MEMORANDUM

<i>To:</i>	Landon Stoddard, Gilbane	<i>Date:</i>	April 10, 2017
<i>From:</i>	Brandon Kent, AIA, Gould Evans	<i>Project Name:</i>	ESUHSD – Mt. Pleasant High School Student Center
<i>Cc:</i>	ESUHSD Capital Purchasing, Alex Morrison, Anesu Dhlwayo	<i>Project No.:</i>	1115-0130
<i>Subject:</i>	Response to Gonsalves & Stronck RFI – Dated April 6, 2017

Project: Mt. Pleasant HS
Project No.: #160132.00
Subject: Pre-Bid RFI 001 (Construction RFI 003 – DSA Addendum 002)
Purpose: For your use

P102

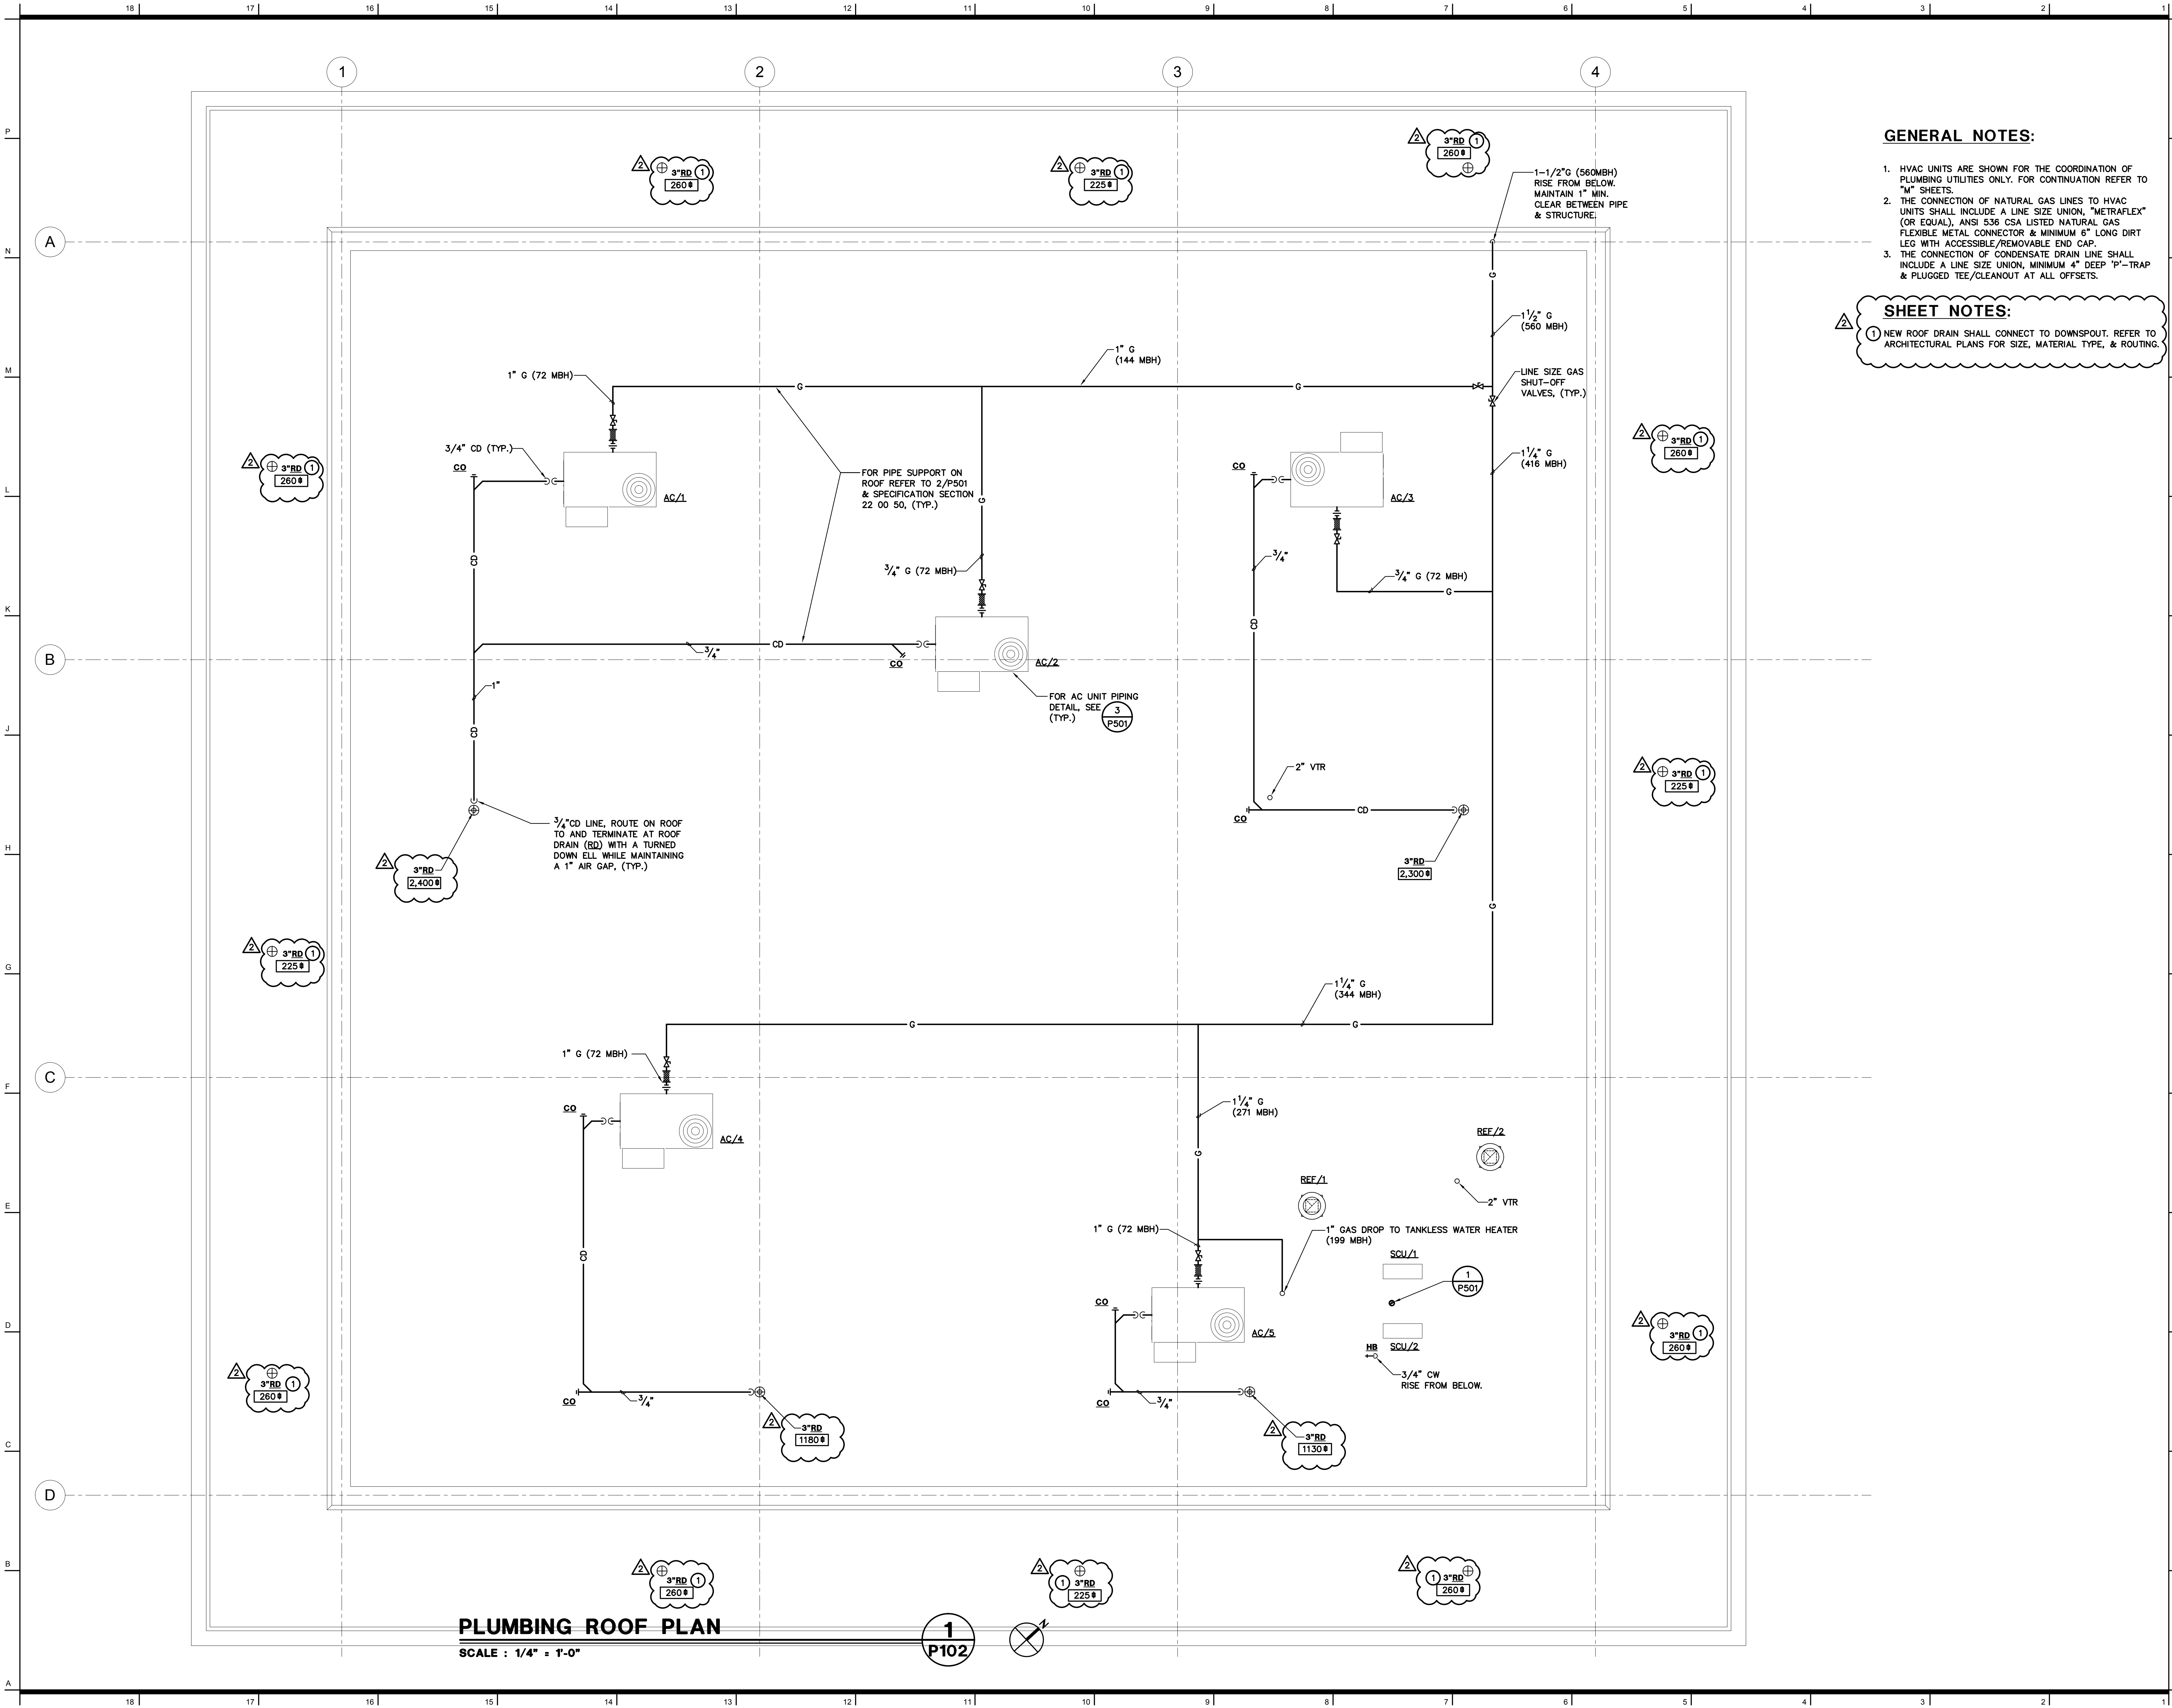
20.1 There is no reference to (N) roof drains as noted by keynote #44 on A131 nor is there any mention of the roof drain piping below the roof deck. Please provide details.

We take no exception to the Contractor's comment that new roof drains indicated on the Architectural Roof Plan were not shown or referenced on the Plumbing Plans.

Response: See updated plumbing drawings attached and sheet C4.00.

With that said, we've revised **Plumbing Plans, PD102 & P102** (see the attached) to show existing roof drains that are to be removed & replaced with new, new roof drains along the outside perimeter of the roof and the connection to new downspouts, etc. All changes made were clouded & included delta #2.

- 1 NEW ROOF DRAIN SHALL CONNECT TO DOWNSPOUT. REFER TO ARCHITECTURAL PLANS FOR SIZE, MATERIAL TYPE, & ROUTING.
